**PROPOSED DEVELOPMENT AT TRINITY WHARF, TRINITY STREET, WEXFORD**  
**Ref PL303726 - FURTHER COMMENT TO AN BORD PLEANÁLA (ABP)**

Following on from our initial submission on the original Application, this further submission is made by Mr. Eoin Reynolds of NRB Consulting Engineers Limited, on behalf of Mr Eamon McMahon of McMahon Building Supplies, Trinity Street, Wexford. All correspondence on this matter should be addressed to NRB Consulting Engineers at the above address.

This further submission relates specifically and solely to the location and design of the proposed vehicular access from Trinity Street, and in particular to established Rights of Way, Operational, Loss of Parking and Traffic Safety issues. It addresses the content of the Further Information Response submitted by Wexford County Council dated October 2019.

Figure 3 - Current Access for Vast Majority of Deliveries (Defined by Red Dash)

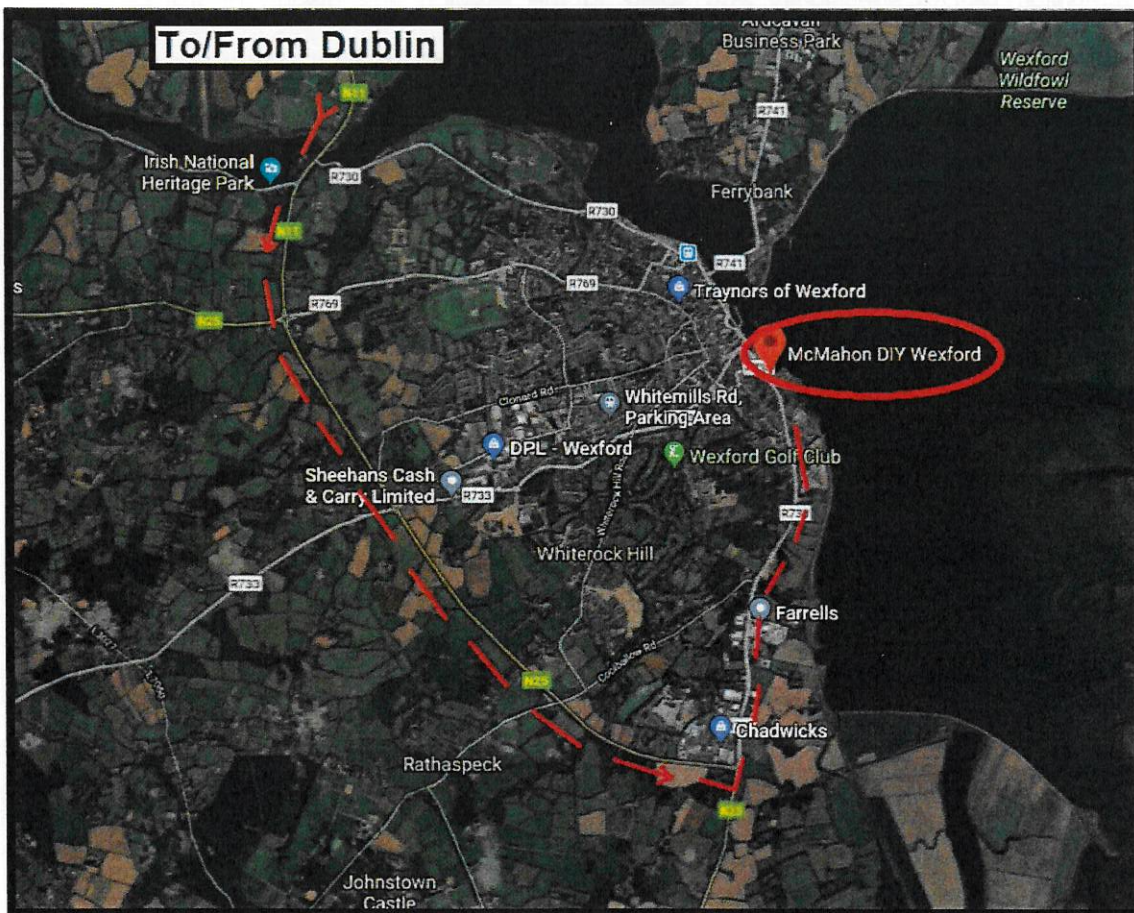
- Currently the McMahons Business premises benefits from complete and unfettered access for all vehicle types, with long established Rights of Way from North and South along Trinity Street.
- The majority of deliveries of building products are by way of 16.5m Articulated Lorry coming from the Dublin Direction, as illustrated in **Figure 3** below;

So, it is clear from the above that Deliveries by 16.5m HGV, and all vehicle types, have established access and routes around the N25 Wexford Ring Road, approaching along the Rosslare Road from the south along Trinity Street. We would be concerned how these Delivery Vehicles would be expected to "Circle the Block", as suggested by ROD, and the implications for same. We would query how vehicles of the size and scale of that illustrated in **Figure 4** below can be expected to "circle the block" in a built

**Figure 7 - Traffic Signal Equipment will interfere with Ped/Cyclist Shared Surface**

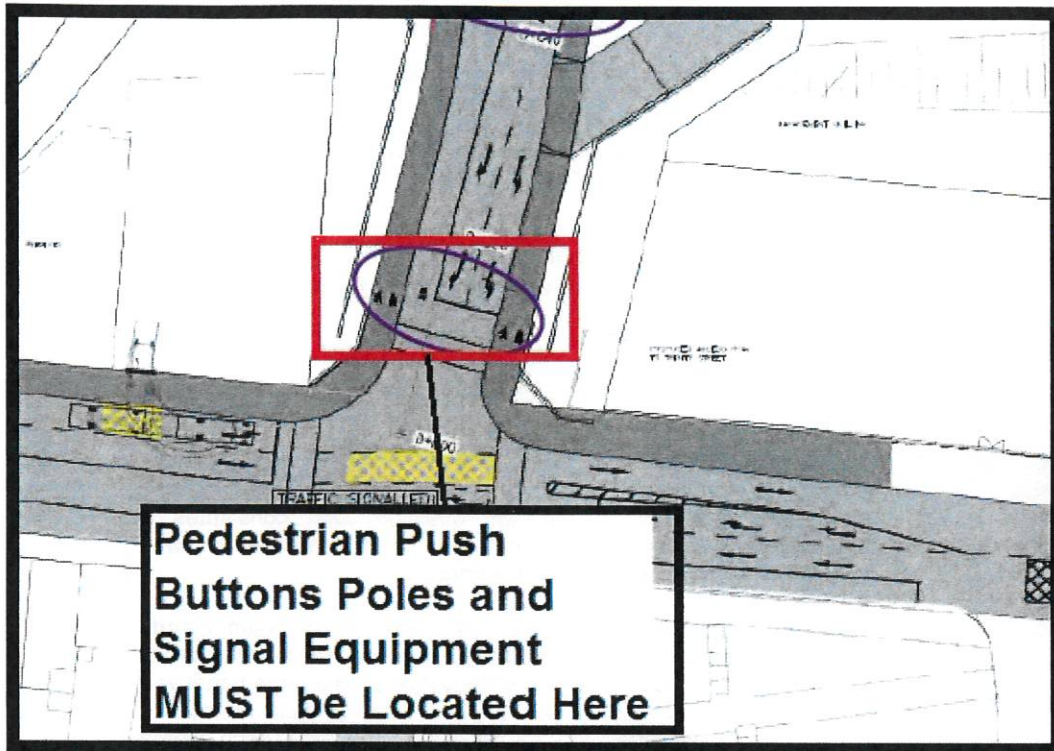
We highlighted this in our original submission AND it remains unaddressed and of concern - Correctly and safely locating signal equipment is particularly important for example where Traffic Signal Equipment and Poles will of course have to be located on an intended Shared Pedestrian/Cycle Track, as illustrated in **Figure 7** below; -

In the case of the subject junction, we believe that the addition of signal equipment will have the effect of confirming the safety deficiencies of the junction in the current location - this opinion remains valid today, and is generally as set out in our original submission.

Figure 11 - Extract from NRB Drawing NRB-AP001 illustrating Problem Alignment issues

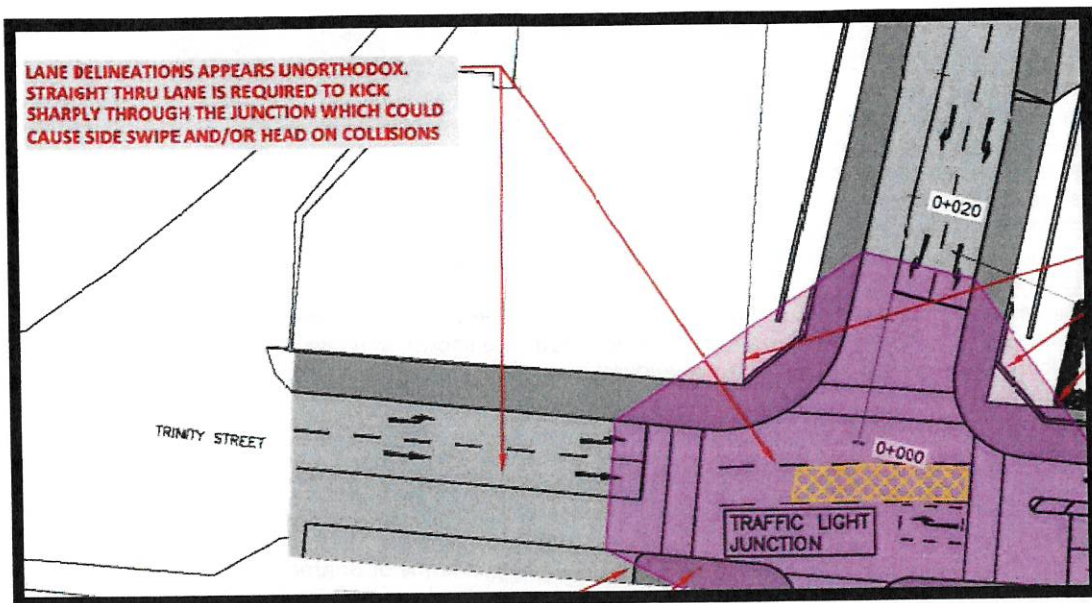
3.8	"The detail design of the junction will include a full street lighting design which will ensure the alignment of the through movement is clear and easily understood "	We would highlight that their own Auditor states alarmingly " <b>Southbound drivers travelling straight ahead may sight into the opposing right turn lane leading to head-on collisions</b> ". The Auditor then recommends; - " <b>Provide measures that safely direct drivers through the junction and into the appropriate straight ahead lane</b> " This was highlighted on our Drawing AP-001 which was submitted originally, and we include below an extract illustrating the concern as <b>Figure 11 Somewhat incredibly, the applicant proposes to address this issue at Detailed Design stage through Designing Street Lighting. Street lighting does not remedy poor lane alignment issues</b> - We would suggest that ABP may wish to question what street lighting does to aid poor alignment. Actually, as specialist designers, what needs to be done is to alter the junction geometry and provide a right turn shelter on the southbound approach - However there may be inadequate land in the junction location chosen by WCC/ROD to provide same. As per above - it reinforces the view that ALL of these issues together should be shown on a Drawing AND & re-audited in accordance with best practice

*Figure 17 - Extract WCC Response, Item 5.7(c)(ii)*

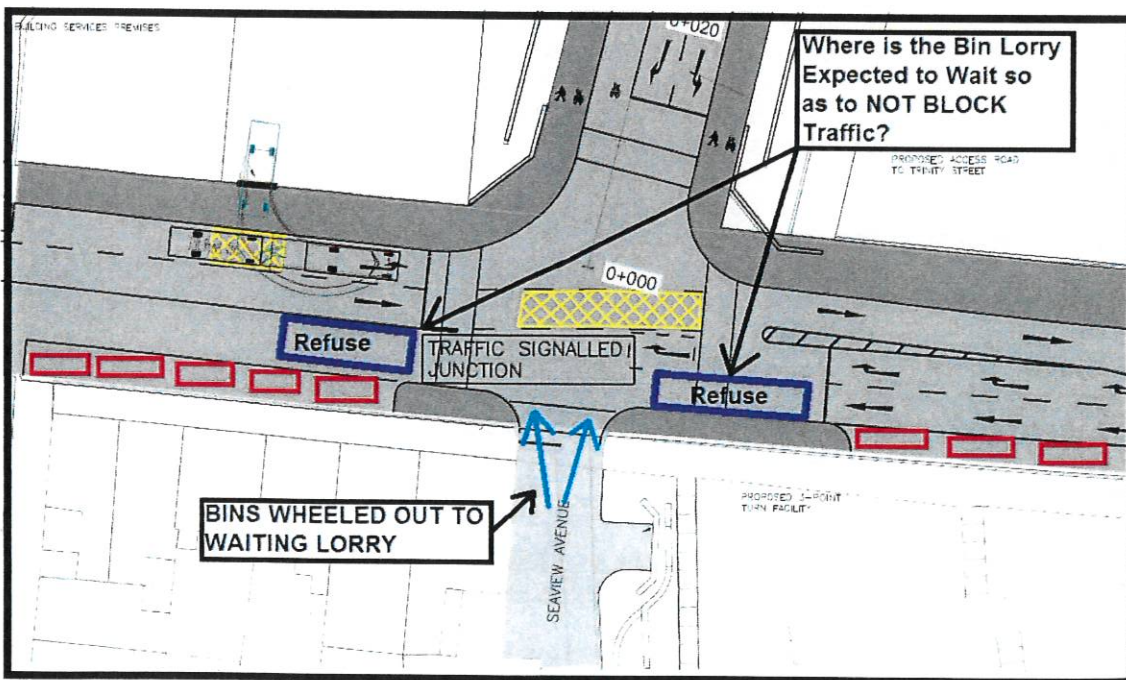
This is addressed above in Table 1, Item 3.1 of the RSA Response. In addition we have used an annotated Extract from the ROD Drawing below as *Figure 17* to illustrate the problem this presents, and again this is an important issue that has been almost entirely overlooked/ignored by the Applicant Design Team and RSA.

The waiting Bin Lorry will have a very significant *adverse impact upon safe Traffic Progression and/or the forward visibility of the Traffic Signals for Northbound drivers on Trinity Street - in addition it will adversely affect the safety of the Bin Lorry Operatives.*

Figure 19 - Extract - Recommendations for Site Development works for Housing Areas

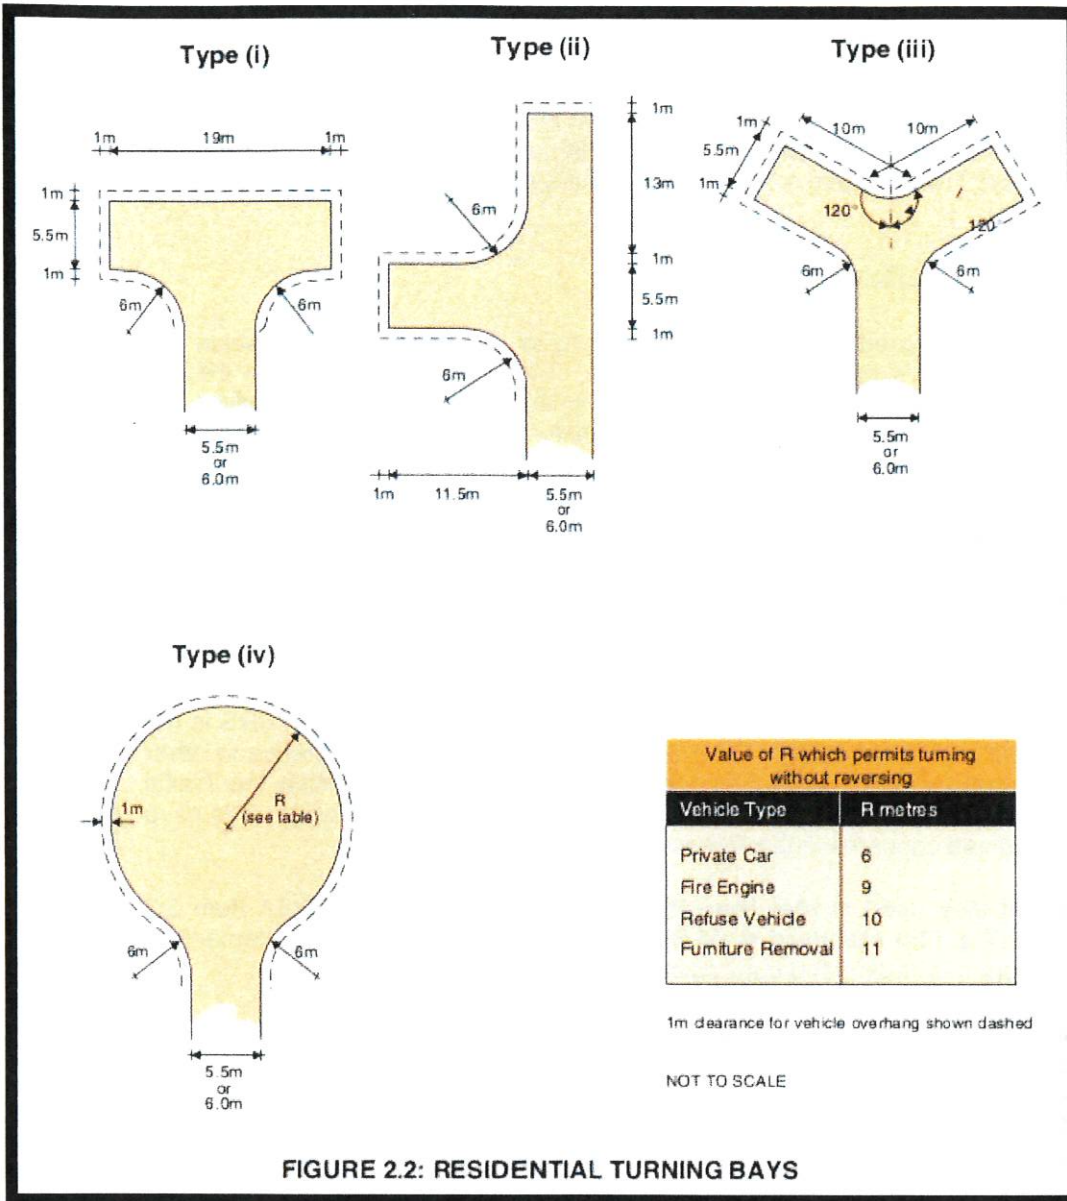
**Provision of the Turning Bay in Seaview Avenue, as proposed by ROD/WCC is, frankly, only slightly better than useless.**

The required minimum sizes for Residential Turning Bays are very clearly set out in the Guidance "Recommendations for Site Development Works for Housing Areas", and we include below as **Figure 19** the illustration from same which sets out a range of sizes and dimensions for acceptable turning bays. We would invite ABP to compare these recommended dimensions with the inadequate facility currently proposed for the residents of Seaview Terrace.

Figure 23 - Extract From Applicants own RSA Highlighting Problems with Swept Paths

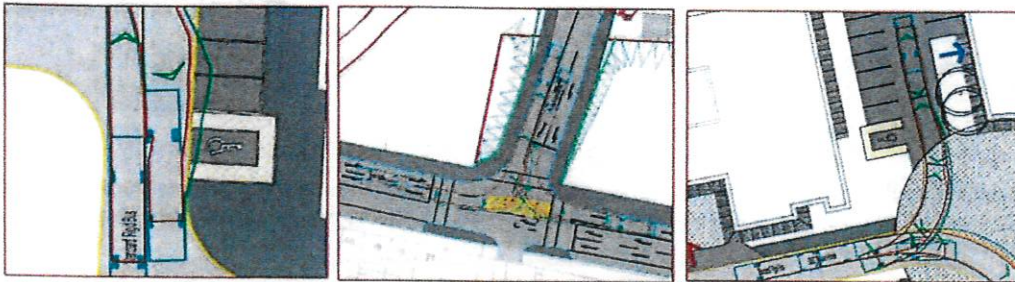
- In terms of remaining "Lane Correct" we would question the validity of this WCC statement when the **Applicants own RSA contradicts this**, reproduced below as **Figure 23**. In the central image below, the left-turning 10m long mini bus entering the site is clearly shown having to 'sweep' out into the offside lane to make the left turn manoeuvre. This was highlighted as a concern by the independent Auditor.

Vehicle swept path analysis appears to highlight a number of vehicle movements over-running the proposed footway and parking spaces. If insufficient space is provided, this may lead to vehicles mounting the inside kerb when undertaking turning manoeuvres, resulting in pedestrian/vehicle collisions.

**Figure 25 - Extract From Attached NRB Drawing NRB-OB-001A**

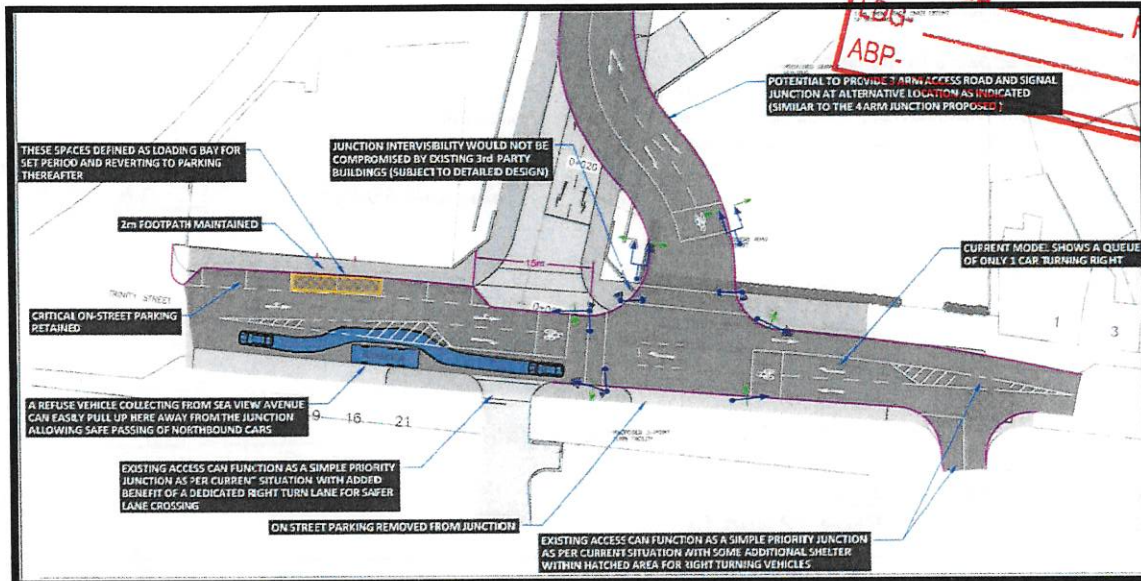
We believe that there is a Simple Safe alternative available to WCC and ABP that will provide a Safe and Acceptable Solution to the site vehicular access **for all Parties** AND which addresses the Myriad of Traffic Progression and Traffic Safety issues associated with the current design.

The principle features of this suggested alternative access solution involve the movement of the currently-proposed Traffic Signal Controlled Junction some 20-25m North along Trinity Street to the location illustrated. **(Of course it could also be moved significantly further north along Trinity Street, with no or limited interaction with Seaview Avenue or McMahons further easing all concerns).**

In addition, it is noteworthy that Seaview Avenue does NOT need to be signal controlled under this arrangement, as vehicles are exiting to the rear of the Signal Stop-line.
